S E R V I C E N O T E

6813B AC Source/Analyzer

Serial Numbers: US38390001- US38399999, MY41000101- MY41001113, SG41000101- SG41000217

Rev. 16

Figure 1. A7 Inverter PCA Top View

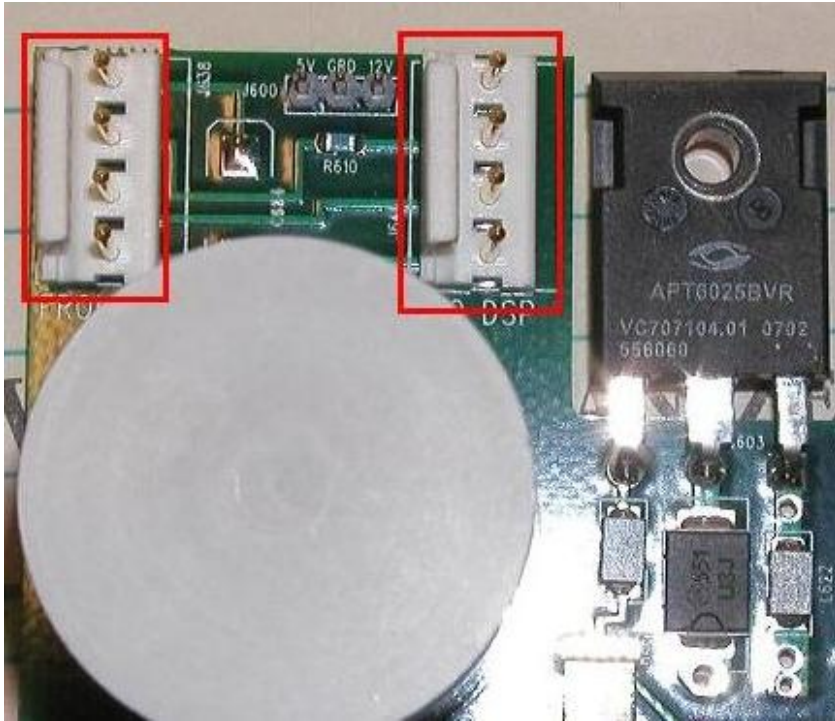
The first two connector headers are J638 and J646 on the A7 Inverter PCA. They need to be changed to the four pin connector, part number 1253-7410. These connectors should be fairly easy to de-solder.

Figure 3. A7 Inverter PCA Top View

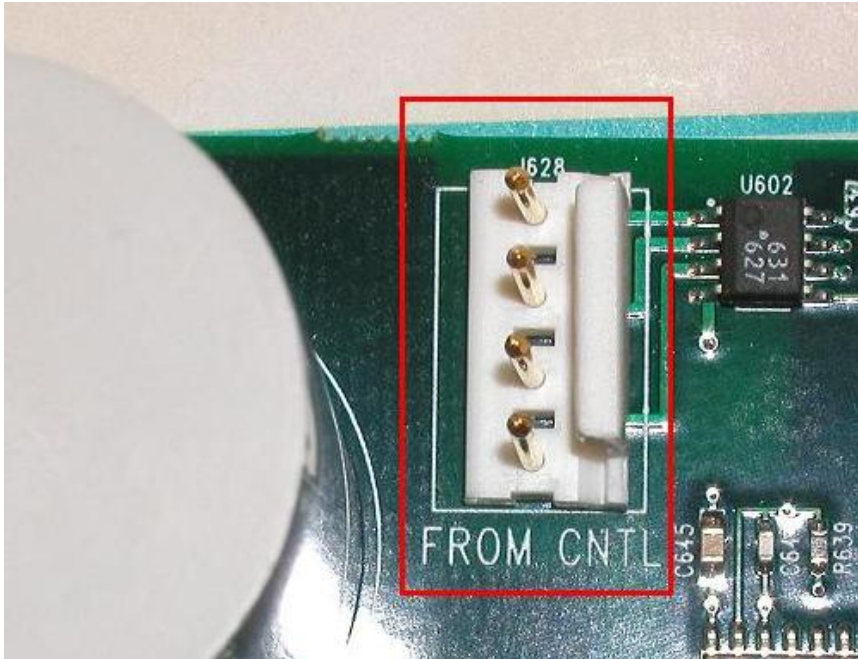
J628 on the A7 Inverter PCA also needs to be changed with part number 1253-7410. This should also be easy to de-solder.

Figure 5. A8 DSP PCA Top View

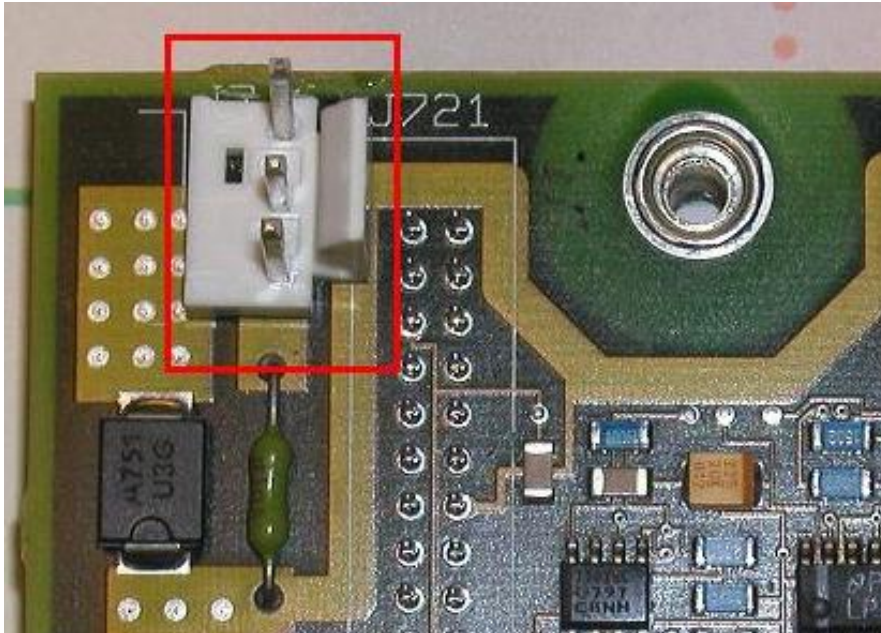
J721 on the A8 DSP assembly must also be changed. This is a three pin connector and should be changed to part number 1253-7460. This connector is hard to de-solder due to it being on top of a ground plane so extra care must be taken in order to avoid damaging the PCA. It is recommended to use solder wick instead of a de-soldering station.
